**MINERALS PROGRAM INSPECTION REPORT**  
**PHONE: (303) 866-3567**

<b>MINE NAME:</b> Jenkins Site	<b>MINE/PROSPECTING ID#:</b> M-1977-393	<b>MINERAL:</b> Sand and gravel	<b>COUNTY:</b> Boulder
<b>INSPECTION TYPE:</b> Monitoring	<b>INSPECTOR(S):</b> Amy Eschberger	<b>INSP. DATE:</b> November 5, 2019	<b>INSP. TIME:</b> 08:30
<b>OPERATOR:</b> City of Boulder	<b>OPERATOR REPRESENTATIVE:</b> Chris Lawlor and Matt Ashley	<b>TYPE OF OPERATION:</b> 112c - Construction Regular Operation	
<b>REASON FOR INSPECTION:</b> Normal I&E Program	<b>BOND CALCULATION TYPE:</b> None	<b>BOND AMOUNT:</b> \$0.00	
<b>DATE OF COMPLAINT:</b> NA	<b>POST INSP. CONTACTS:</b> None	<b>JOINT INSP. AGENCY:</b> None	
<b>WEATHER:</b> Clear	<b>INSPECTOR'S SIGNATURE:</b> 	<b>SIGNATURE DATE:</b> November 14, 2019

# M-1977-393 / Jenkins Site / City of Boulder (112c Permit)

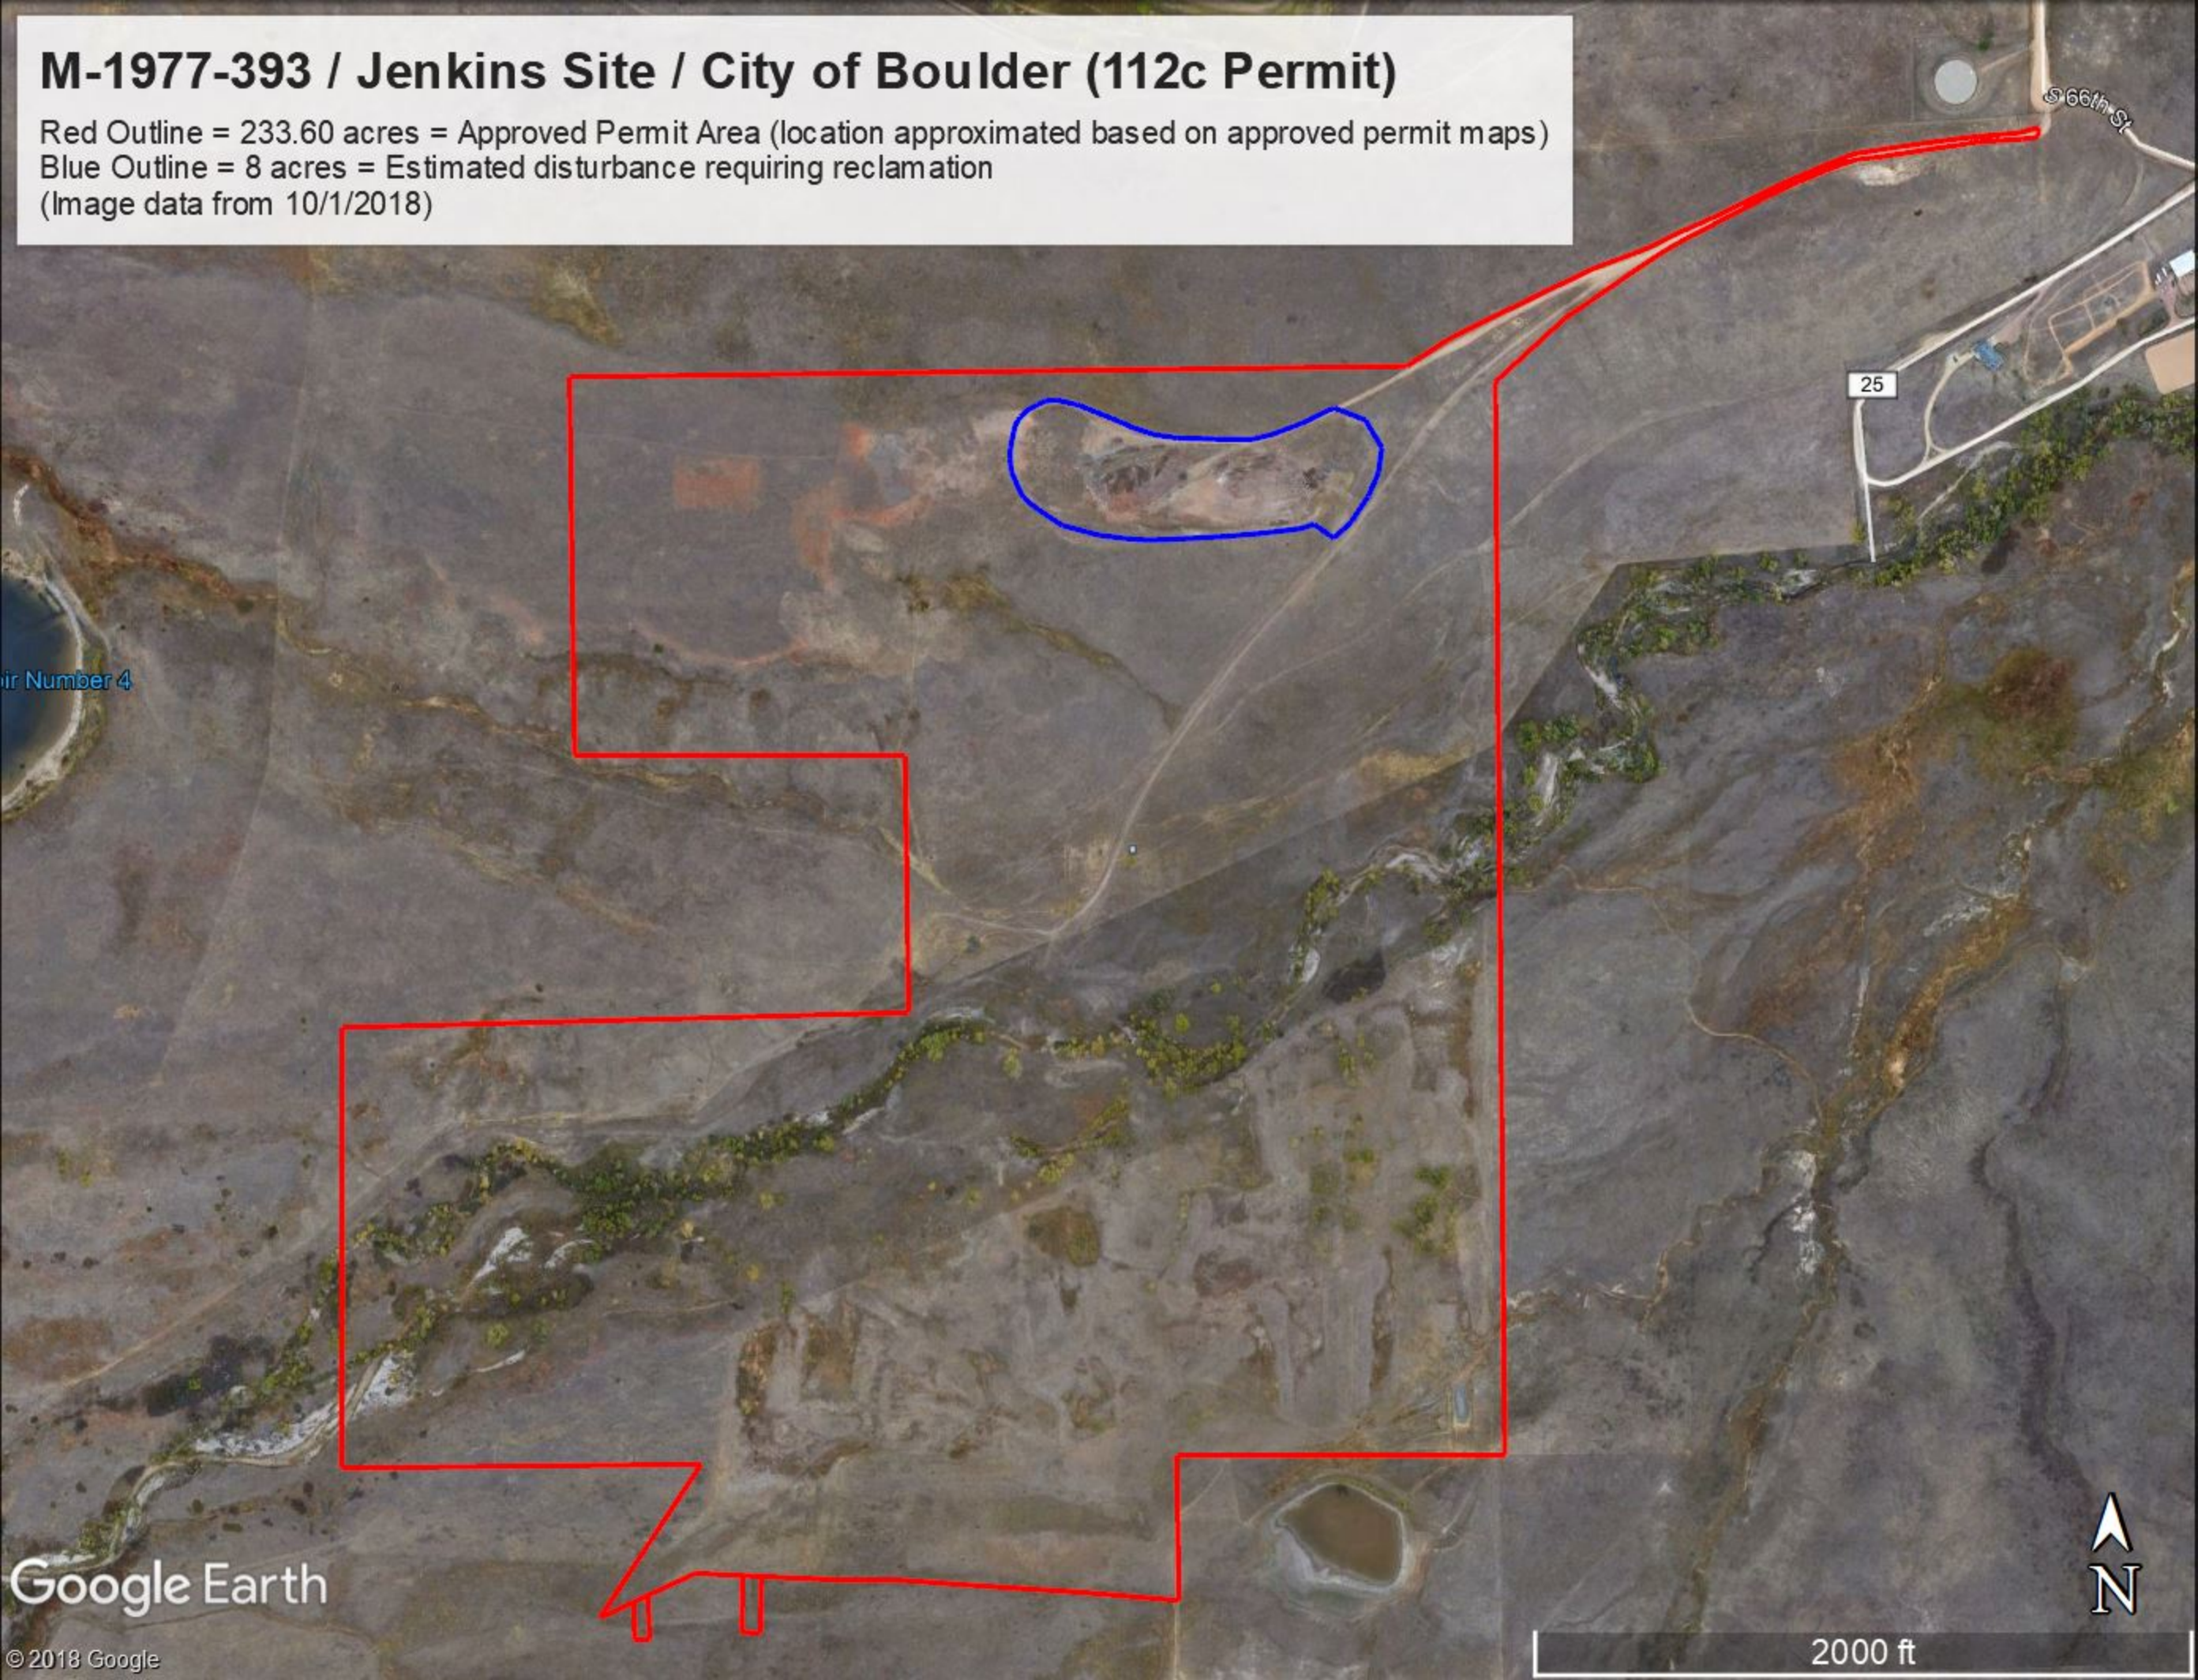
The Division observed the pit located at the top of the mesa in the north mining area, which the operator is continuing to backfill from west to east, in two primary lifts. The lower lift is approximately 25 feet in height with slope gradients of 1.5H:1V to 2H:1V. The upper lift is approximately 15 feet in height with slopes gradients of 1H:1V to 1.5H:1V. The eastern edge of the upper lift is currently approximately 450 feet from the eastern edge of the lower lift. According to the operator, active dumping occurs on site almost daily during the annual 3-month active period. A few small stockpiles of imported material were stored on top of the upper lift. Besides the active backfilling portion of the pit, all other disturbed lands in the north mining area have been reclaimed with slopes graded to 3H:1V or flatter and a good vegetative cover consisting of grasses and some shrubs. The reclaimed areas appeared to be stable with no erosion issues observed. The Division estimates approximately 8 acres of disturbance requiring reclamation exists in the north mining area.

Red Outline = 233.60 acres = Approved Permit Area (location approximated based on approved permit maps)  
Blue Outline = 8 acres = Estimated disturbance requiring reclamation  
(Image data from 10/1/2018)

# M-1977-393 / Jenkins Site / City of Boulder (112c Permit)

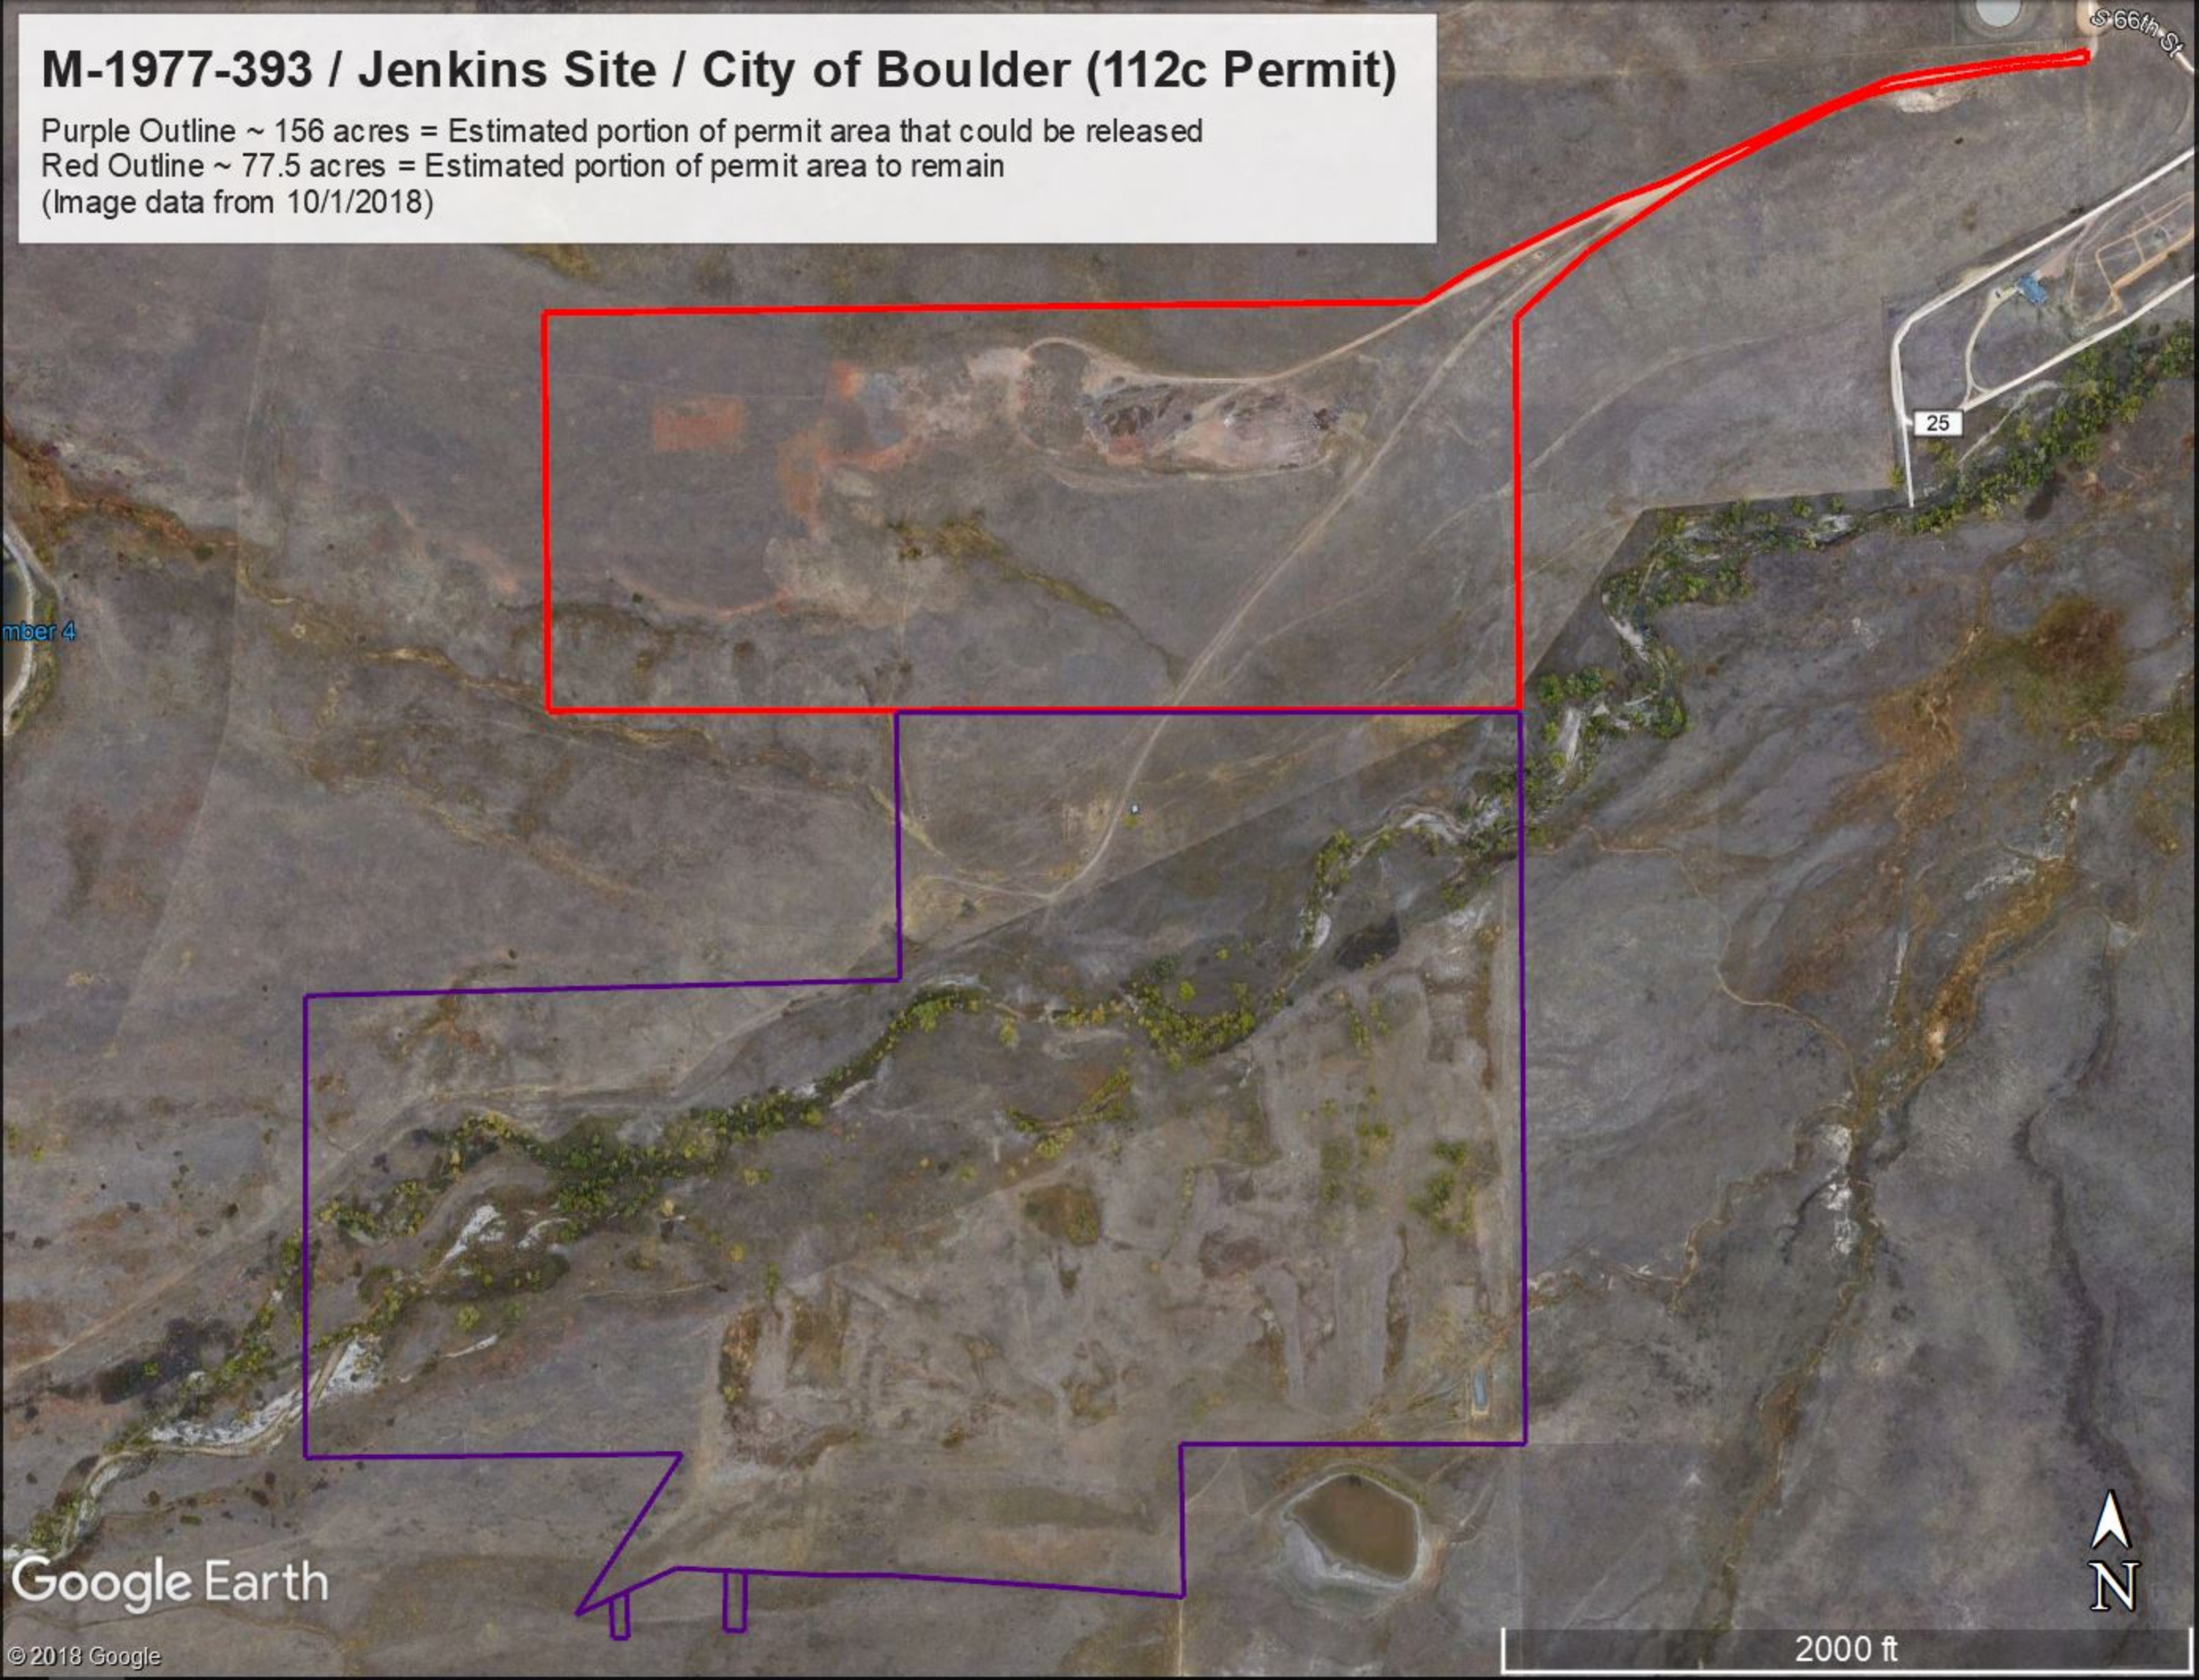
The Division inspected the southern mining area located south of the creek, which has been in reclamation since 1995. The fencing installed in 1999 to restrict livestock grazing in this area was still in place. This area has a somewhat hummocky topography, with all slopes graded to 3H:1V or flatter. The area is stable with established vegetation consisting primarily of native grasses, with some mature trees growing in lower level areas. The south mining area appears to have been reclaimed in accordance with the approved reclamation plan. Therefore, the Division encourages the operator to submit an Acreage Reduction request (AR; see enclosed form) to release this portion of the permit area. The Division estimates the operator could release approximately 156 acres from the permit area (see enclosed Google Earth image of site showing releasable area), leaving approximately 77.5 acres in the portion of the permit area located north of the creek. However, the operator will need to survey the site and determine exactly how many acres are proposed for release, and provide a site map with the AR showing these area(s) accordingly.

Purple Outline ~ 156 acres = Estimated portion of permit area that could be released  
Red Outline ~ 77.5 acres = Estimated portion of permit area to remain  
(Image data from 10/1/2018)

If the Division approves an acreage reduction for the site, the operator will need to submit a Technical Revision (form enclosed) with a revised reclamation plan map (a revised mining plan map is not necessary given the site is in reclamation) showing the new permit area. If the operator wishes to propose any changes to the approved reclamation plan, such as to the revegetation plan (as proposed in 1997), this could be done through the same
